Work Order ID 149540

Revision ID: URF 15-560

Item Name: Replacement Skidtube with Run-on Landing Wearplates, Fits LH or RH

Under Review Notification

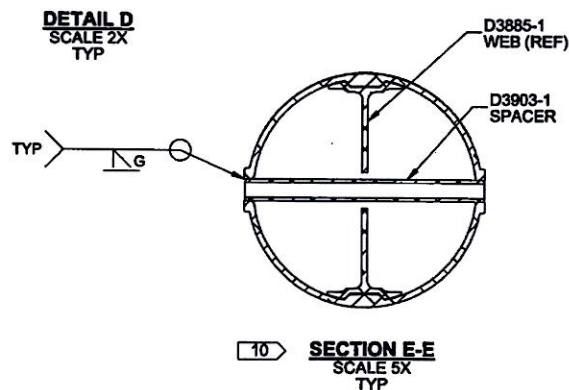
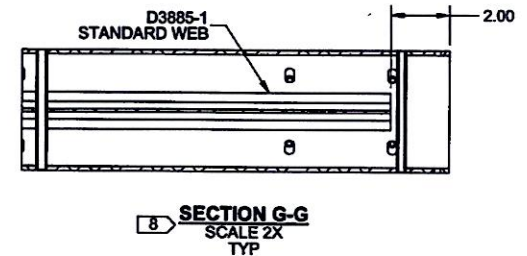
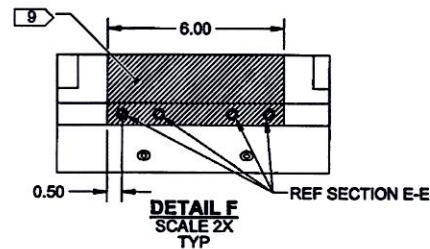
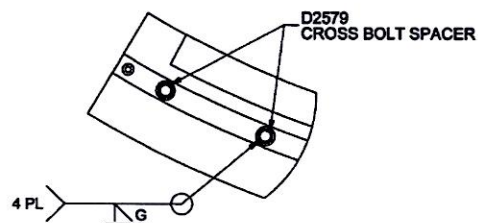
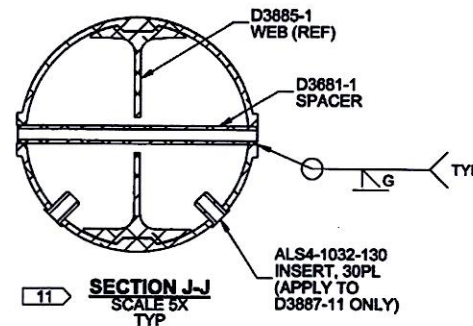
1-***MASK AREA SHOWN ON SHEET 7, NOTE 9***

- 9) MASK THIS AREA AND DO NOT POWDER COAT
- 10) AFTER DRILLING AND BENDING ASSEMBLY, PERFORM THE FOLLOWING FOR THE SECTION E-E $\phi 0.375$ HOLES ONLY:
